**Statement of Compliance
Access for People with a Disability**

**Proposed Mixed Use
Development**

1 Bilambee Ave Bilgola Plateau

Report Type: Statement of Compliance - BCA Access Provisions
Development: 1 Bilambee Ave Bilgola Plateau

SEPP 65 – Part 4Q1

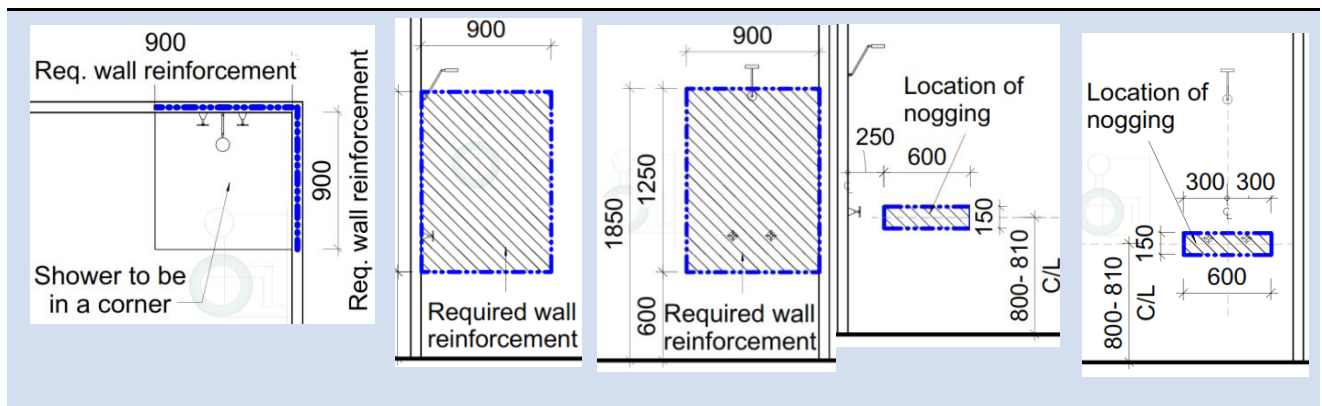
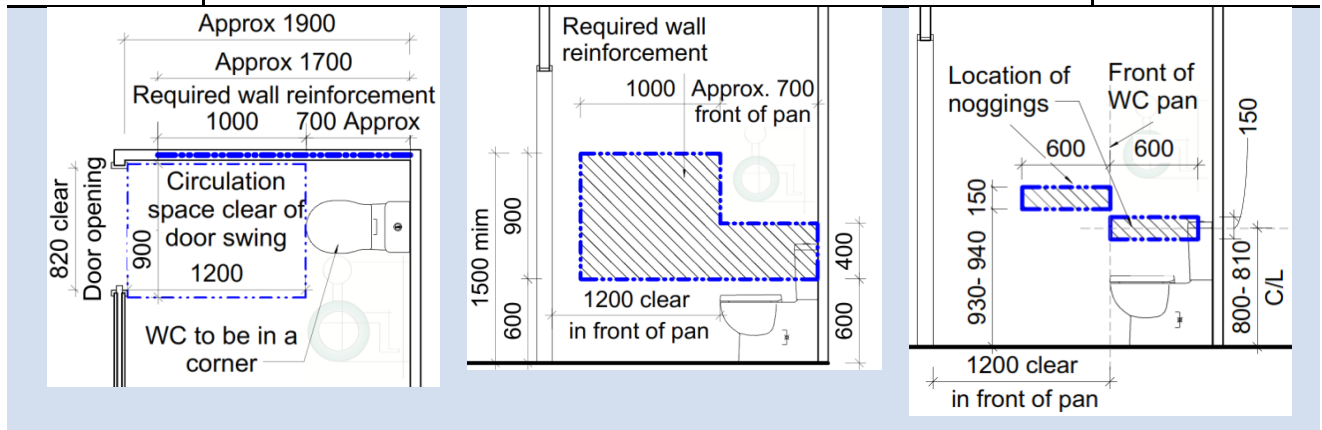
Compliance assessment with Objective 4Q1 that requires 20% of the units to incorporate the features of the **Livable Housing Guidelines Silver level**.

Total number of residential units in the development = 20% of 8 = 2 = **2** required Livable units.

By incorporating the requirements of the below Checklist in the Specifications of the project, the nominated Livable units can achieve full compliance with Livable Housing Guidelines- Silver Level
